Seismic Walkdown Checklist (SWC)

Equipment ID No. R30P320 Equip. Class¹ 20, Instrumentation and Control Panel

Equipment Description EDG 12 – Engine Gauge Panel

NJPR-12-0043

Photo 6, Mounting Plate Bolt and Elect Cable and I&C Tubing in Lower Right Corner of Panel

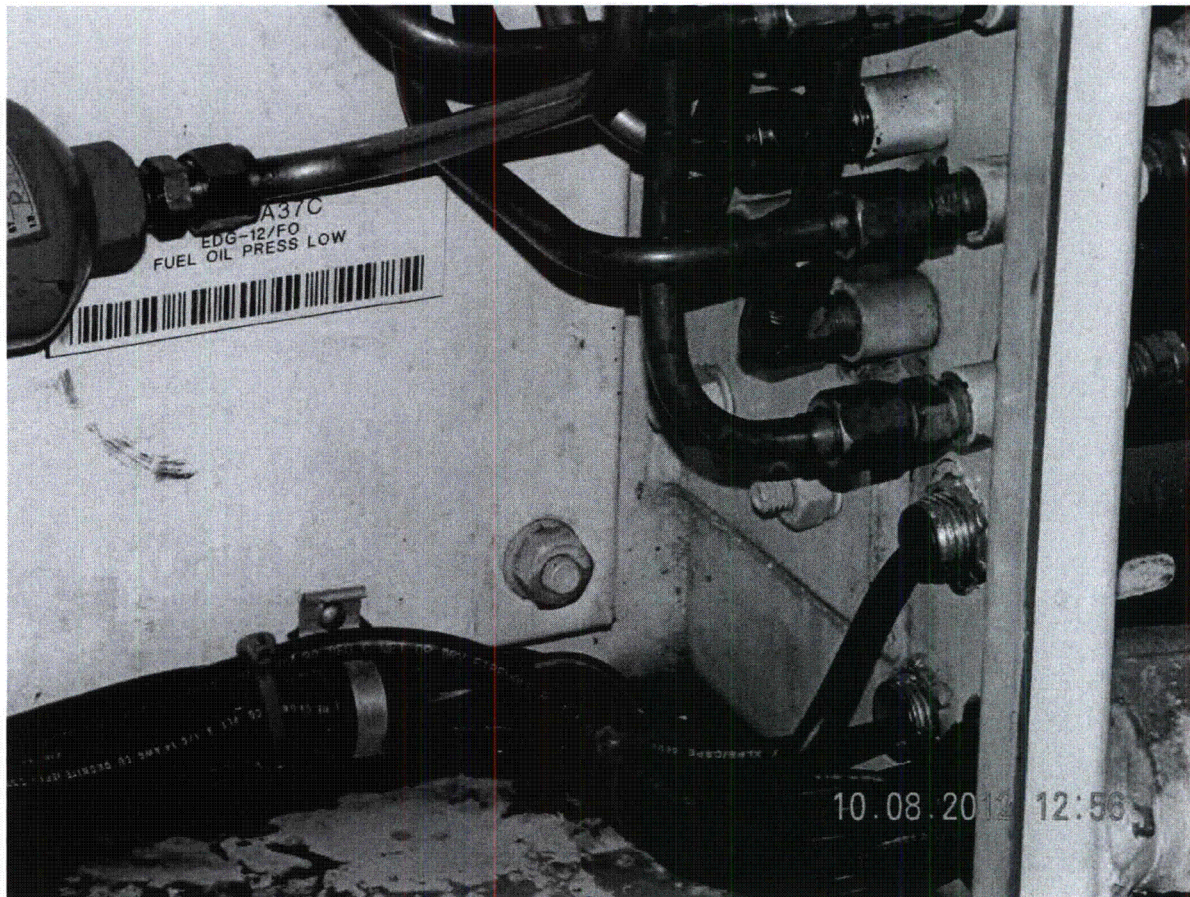
11. Have you looked for and found no other seismic conditions that could adversely affect the safety functions of the equipment? Y N U
The door on the instrument panel was opened to permit evaluating the adequacy of fasteners securing components inside (see Photo 1). None of the components weighed more than ten pounds (see Photos 2-4). Verified adequacy of seismic clearance between bolt on back mounting plate and I&C tubing penetrating upper right corner of panel (see Photo 5). In lower right corner, determined stains at bottom of panel were primarily due to a thin film of dirt and not a sign of serious corrosion (see Photo 6). No adverse conditions were identified.

(Picture 3)

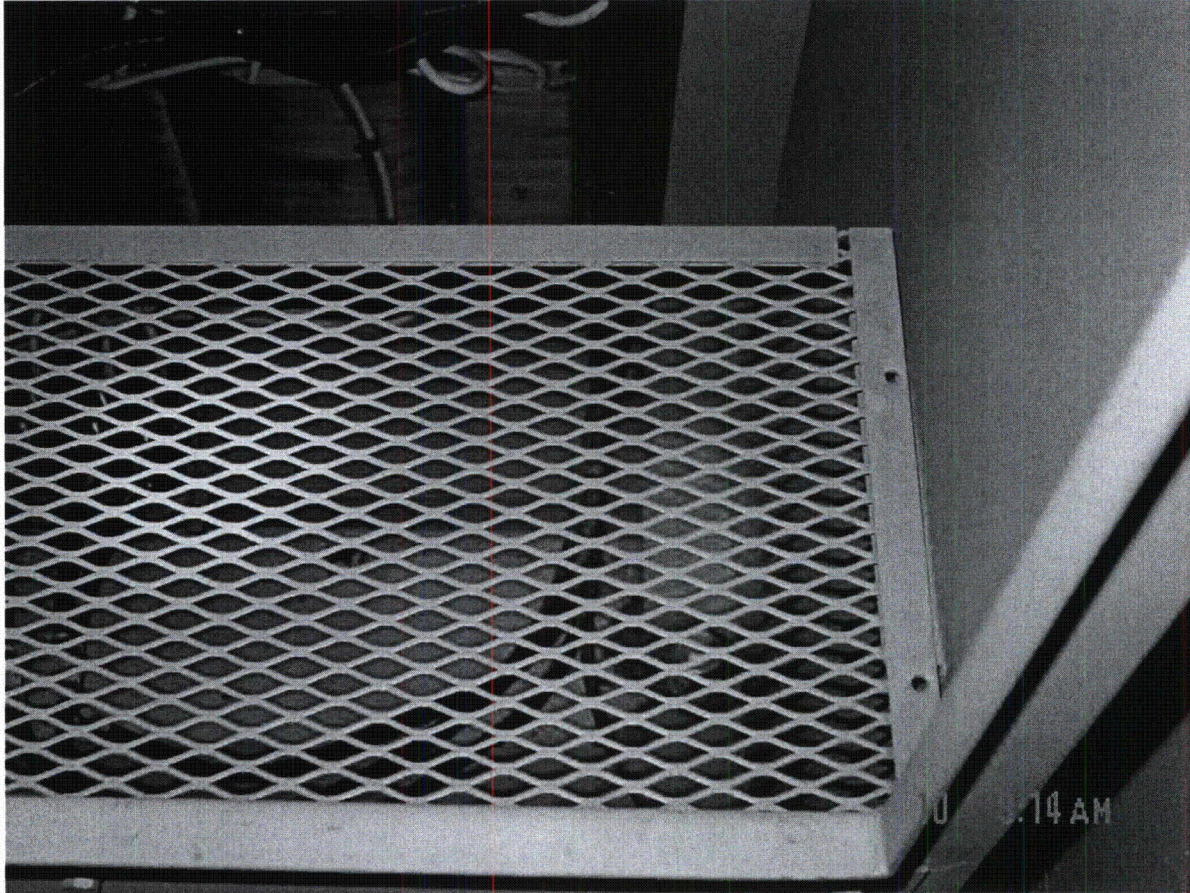
11. Have you looked for and found no other seismic conditions that could adversely affect the safety functions of the equipment? Y N U
During the walkdown it was noticed that 4 screws were missing from the panel's interior protective grate. The existing condition was evaluated by the SWE's by calculation and determination acceptable during a seismic event. See CARD 12-27360 for resolution.
(SEE PICTURE 3) ~ DJR 10/11/12

(Picture 4)

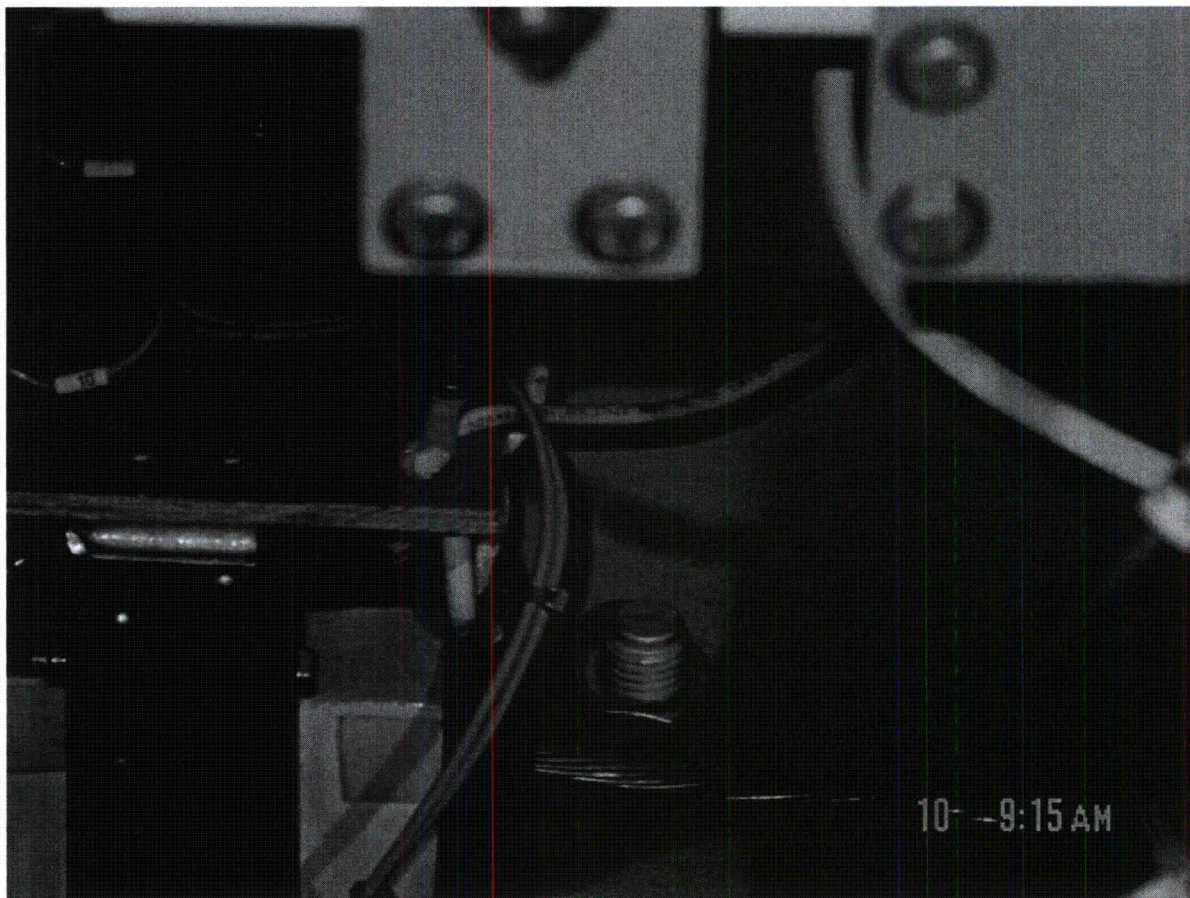
2. Is the anchorage free of bent, broken, missing or loose hardware? Y N U N/A
Anchorage was viewed from outside the panel and was in good condition. (See Picture 4.)

(Picture 6)

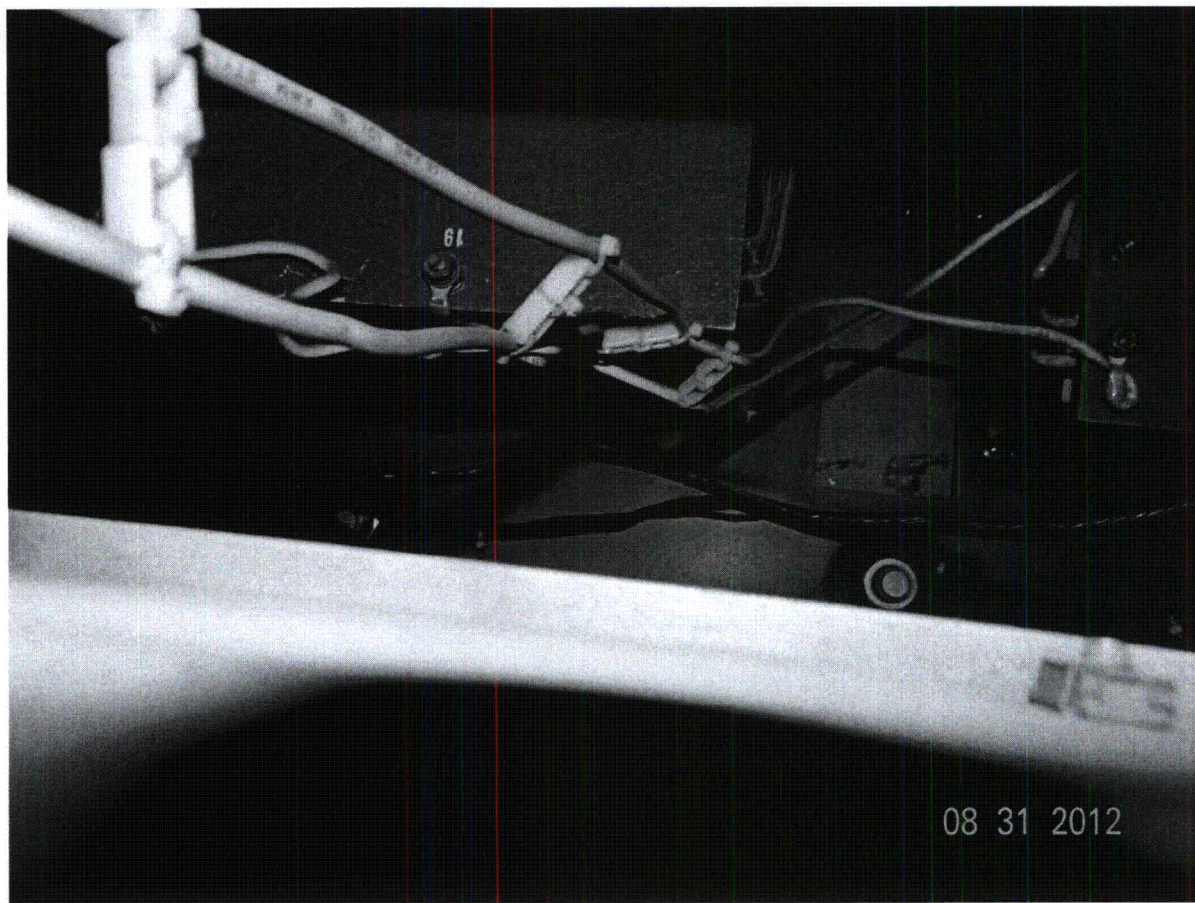
5. Is the anchorage configuration consistent with plant documentation? Y N U N/A
(Note: This question only applies if the item is one of the 50% for which anchorage configuration verification is required.)
*All anchors observed to be in the proper layout and conform to Calc. DC-6037 VOL I, Rev. C. One anchor was not immediately visible, but it was confirmed to be in place during a follow-up inspection. * See Comments and Picture 6. DC-6037 VOL. I, Rev. C HAS NO APPLICABLE POSTINGS.*

(DSCN0055)

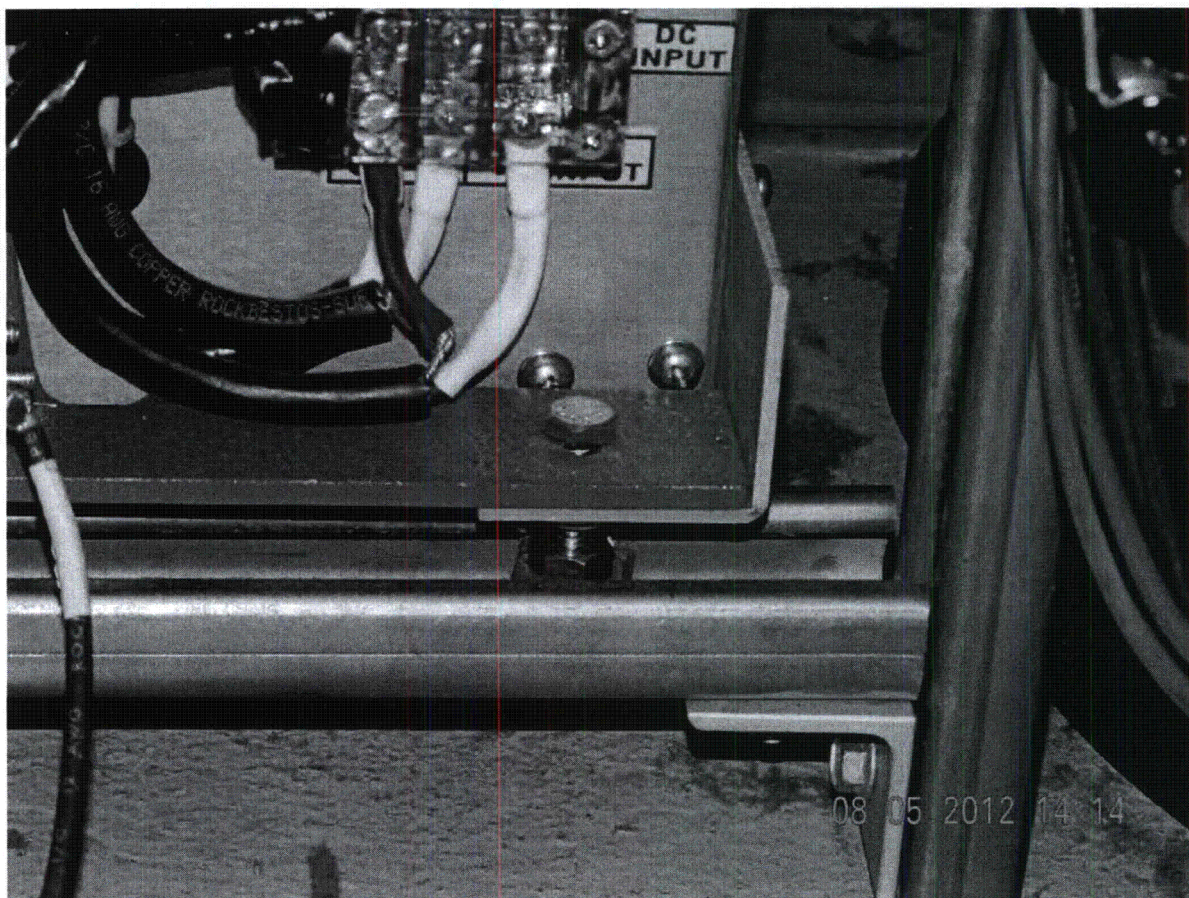
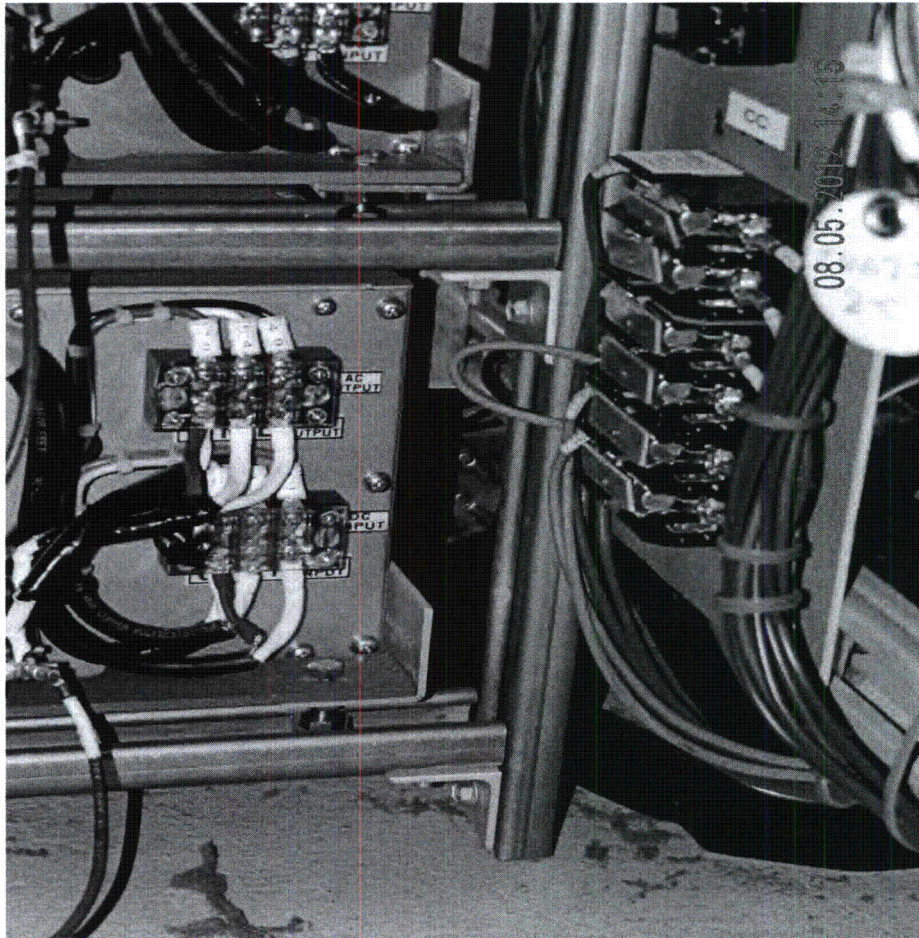
4. Is the anchorage free of visible cracks in the concrete near the anchors? Y N U N/A
*Equipment is mounted in a cabinet, not to concrete.
(SEE PICTURES D5CN0055, D5CN0057) ~ DJK 10/11/12*

5. Is the anchorage configuration consistent with plant documentation? Y N U N/A
*(Note: This question only applies if the item is one of the 50% for which an anchorage configuration verification is required.)
Mounting configuration is consistent with plant documentation.
Ref. VMCI-519* & I-2040-08.* | DJK 10/12/12
(SEE PICTURES D5CN0051, D5CN0055, D5CN0057) ~ DJK 10/11/12*

(DSCN0126)

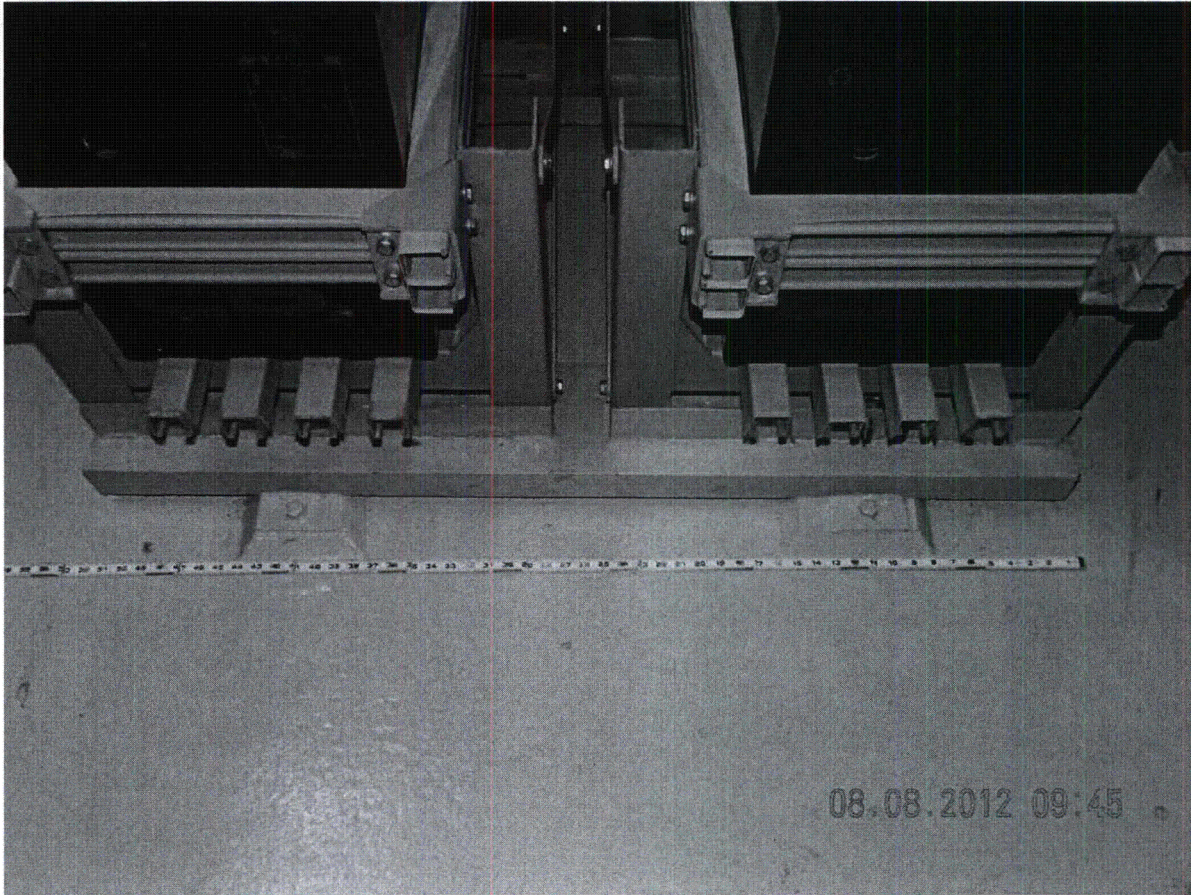
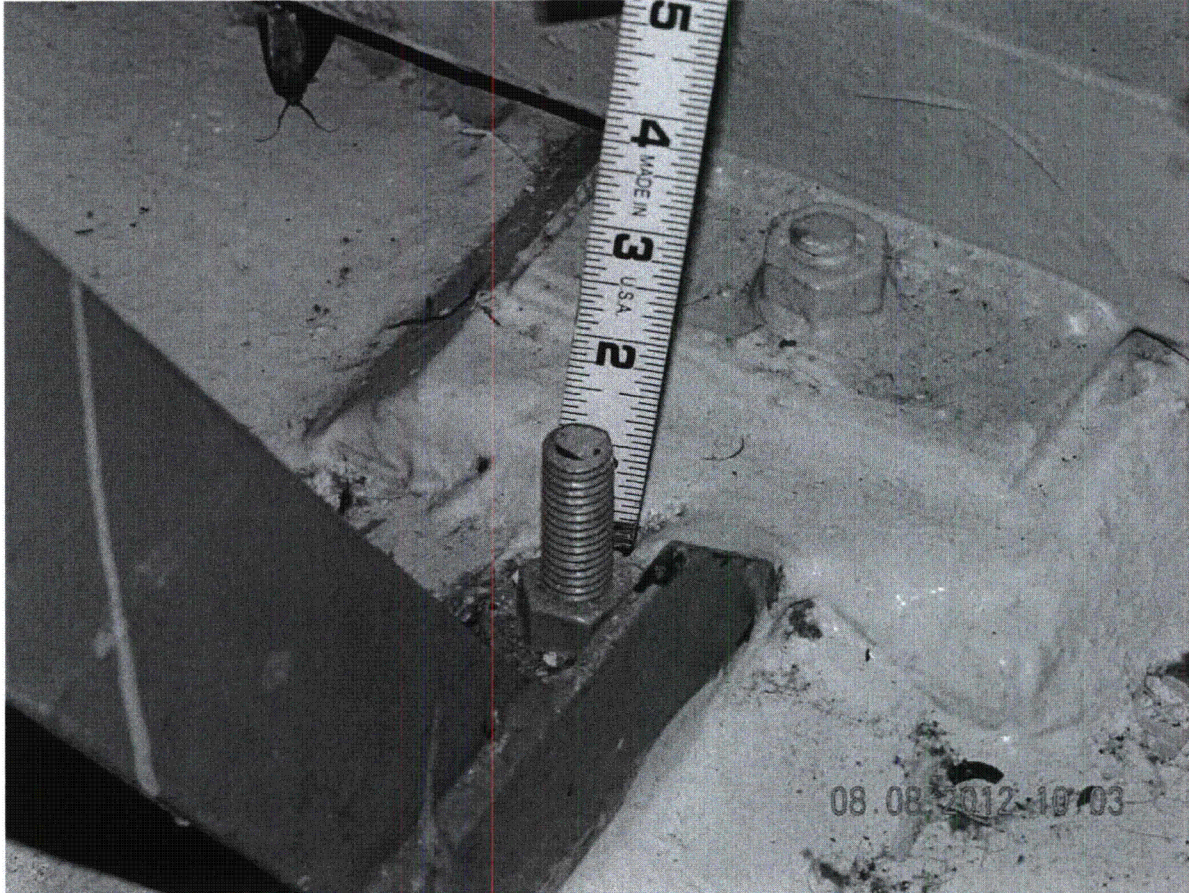
5. Is the anchorage configuration consistent with plant documentation? Y N U N/A
(Note: This question only applies if the item is one of the 50% for which an anchorage configuration verification is required.)
See drawing E-6004-01, REV. Ø (No POSTINGS)
½" bolts to embed gateway - ref. dwg. E-2833-10, REV. F (No POSTINGS) | DJK 10/12/12
(SEE PICTURES DSCN0119, DSCN0126, DSCN0129, DSCN0135) ~ DJK 10/11/12

(DSC0071)

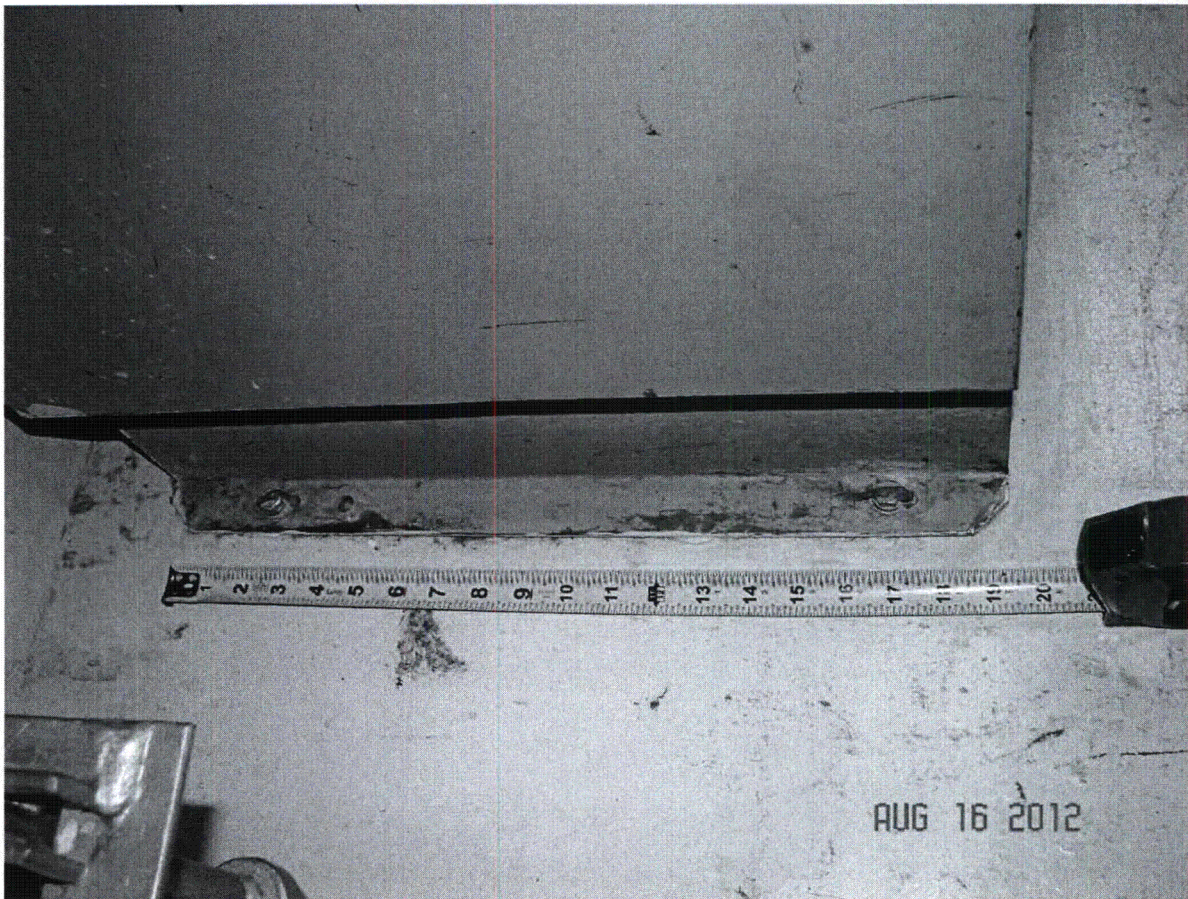
5. Is the anchorage configuration consistent with plant documentation? Y N U N/A
 (Note: This question only applies if the item is one of the 50% for which an anchorage configuration verification is required.)
Installed in accordance with dwg. I-2833-03, 4 - 3/8" Ø bolts. (SEE PICTURES DSC0068, DSC0071) DSK 10/9/12* | *DSK 10/12/12*

Overhead Cable Tray and Flexible Conduits to Battery Charger

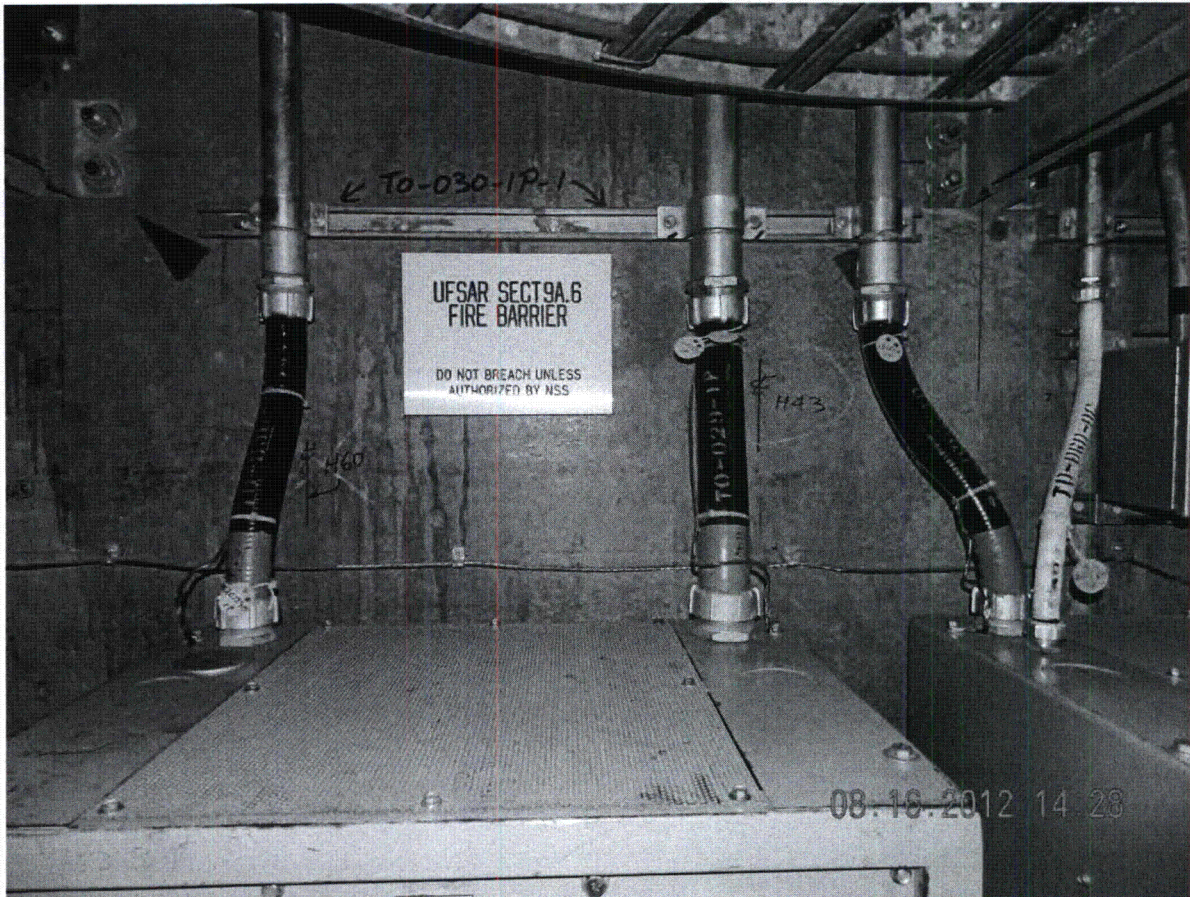
Cables attached to cabinet in flex conduit with loop. Verify flex conduit detail for conduit TO-029-1P. CARD 12-27131 initiated to verify/evaluate issue. JAM 10/18/12

Verify Flex connection of 2" conduit going into top of floor-mounted unit. See CARD 12-27131 for adequacy of flexibility questioned.
